ANALYSIS OF IBOC DAR SYSTEM PROPOSALS

Analysis of USADR IBOC DAR System Modifications and Their Impact on Performance

CONSUMER ELECTRONICS MANUFACTURERS ASSOCIATION
a sector of
ELECTRONIC INDUSTRIES ASSOCIATION

FIGURE 1 FM-1 WITH WESTINGHOUSE PROPOSAL OVERLAID

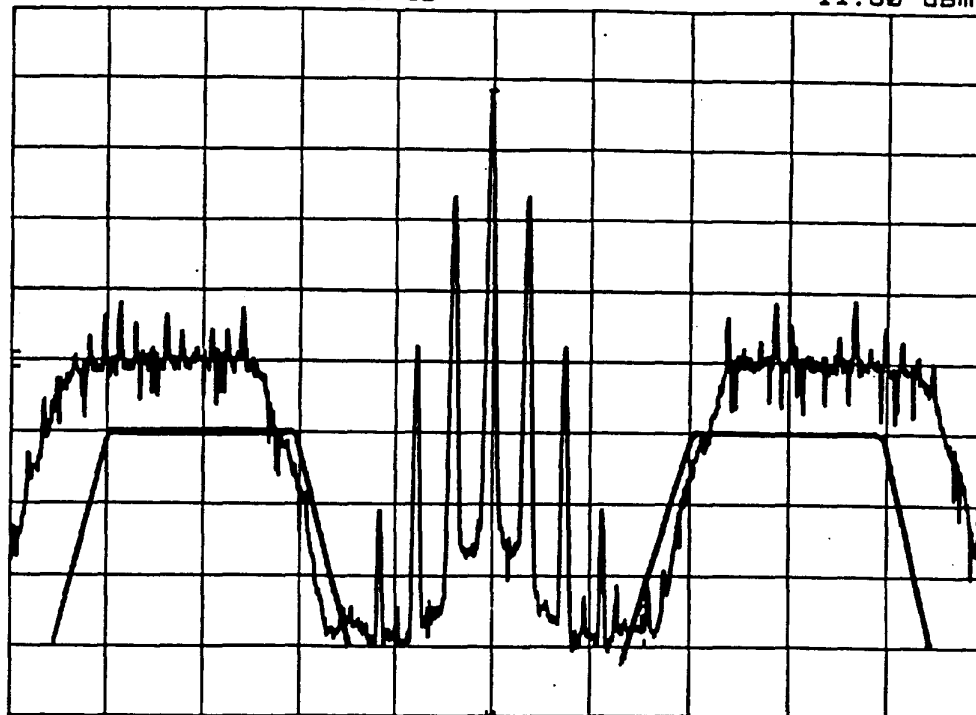
The complete digital signal is duplicated for each digital sideband. The system will operate on the alternate sideband when interference is present. To reduce digital interference to the analog host or adjacent channel analog signals, the digital power is reduced 6 to 10 dB below the level used for the tested FM-1 system. The two independent digital modulated channels (sidebands) start at a frequency ± 100 kHz removed from the channel center frequency and extend to ± 200 kHz from the channel center frequency. Stereo audio source coding rate of 96 kbps, and a channel coding rate of 192 kbps is used. A system of time diversity and switch to time delayed analog FM is intended to reduce the effect of in-motion multipath. Because the two signals are not transmitted at the same time, short multipath events effecting the digital signal will be hidden by the switch to the analog FM stereo. The probability of both channels being effected by multipath at the same time is low. It is clear that for this system to operate, the same program must be transmitted on the analog and digital channels. This is a new feature. Figure 1 is a plot of FM-1 with the new system overlaid.

This proposal substantially changes the frequency spread and power level of the digital sideband signal's. The power is reduced by 6 to 10 dB below the FM-1 levels. The digital signals frequency would be transmitted in two bands 100 kHz wide and run from 100 kHz to 200 kHz above and below the channel center frequency. It can be seen from the results of the above test that many of the compatibility advantages of the proposed digital power reduction may be offset by the transmission of a full amplitude digital signal at 114 kHz.

FIGURE 2 AT&T/AMATI WITH USADR ITU PROPOSAL OVERLAID

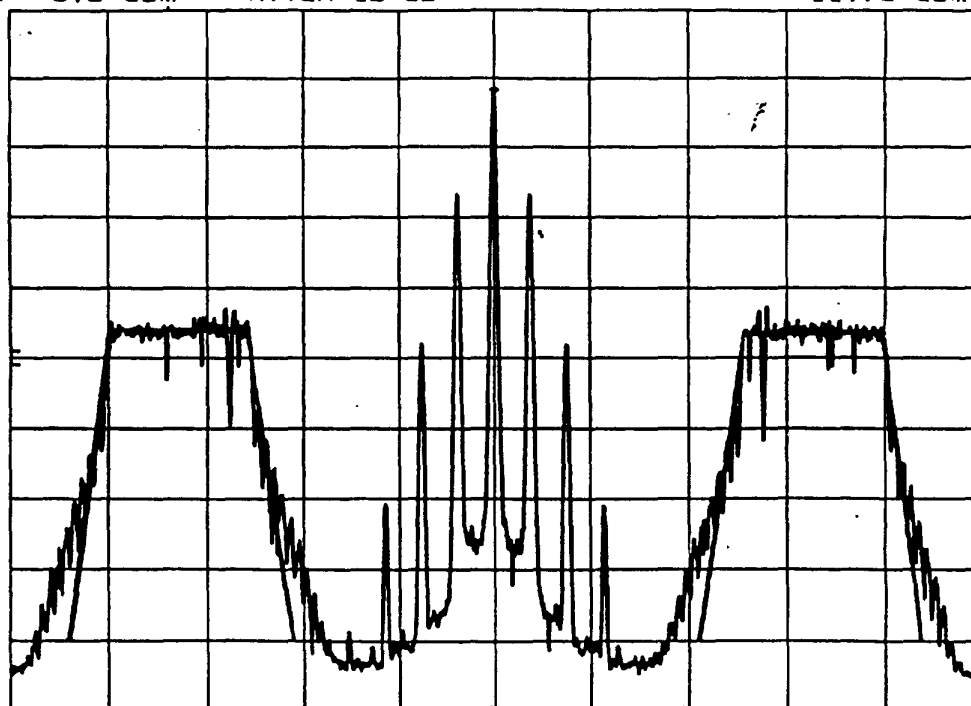
As with the Westinghouse proposal the complete digital signal is duplicated in each sideband. The system will operate on the alternate sideband when 1st and/or 2nd adjacent interference is present. To reduce digital interference to host FM, the two independently modulated digital signals start at ± 129 kHz and extend ± 200 kHz from the FM channel center frequency. This avoids the 114 kHz interference band described in the compatibility section (II) of this paper. To further reduce interference to the adjacent analog channels, the power of the independent sidebands will be determined by a compromise between digital coverage and adjacent channel interference. Figure 2 is a plot of AT&T/Amati System with the proposed system overlaid.

To avoid noise this proposal avoids the 114 kHz band by starting the digital signal at 129 kHz and running it up to 200 kHz above and below the carrier. This avoids the 114 kHz band but transmits a full level signal at 119 kHz. The compatibility tests show that the receivers are also sensitive to the 190 kHz band and avoiding only the 114 kHz band will not solve the IBOC digital -> to host analog compatibility problem.

FIGURE 3 USADR FM-1 SYSTEM

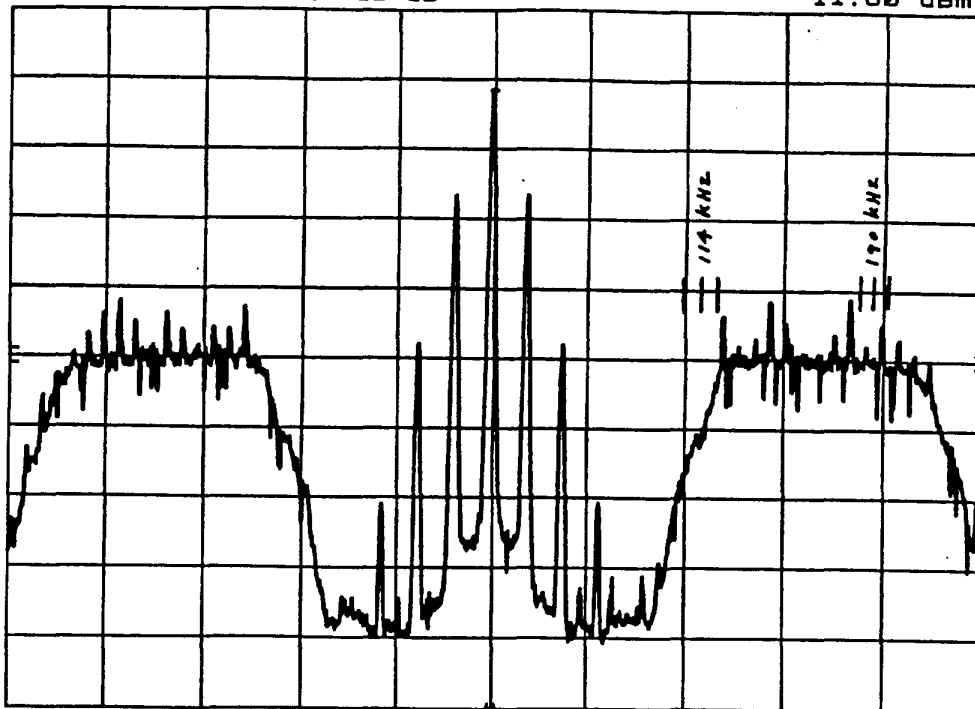
Figure 4 shows a plot of the AT&T/Amati IBOC signal, and Figure 3 the FM-1 systems. The digital PSD for both systems is shown. The 114 kHz and 190 kHz PLL receiver sensitive bands are noted on the upper sidebands. The AT&T/Amati plot (Figure 4.) shows that at 114 kHz the digital signal is down by 23 dB, and at 190 kHz the digital signal is at full amplitude. It can also be seen on the FM-1 plot (Figure 3) that the 114 kHz digital signal is 10 dB down, and the 190 kHz is at full amplitude. The results of the digital -> host analog test (Table 1.) show that even if the system avoided the 114 kHz band, the system had similar noise increase. It can be concluded that for the Amati/AT&T System the 190 kHz frequency band was the major contributor to the noise floor increase.
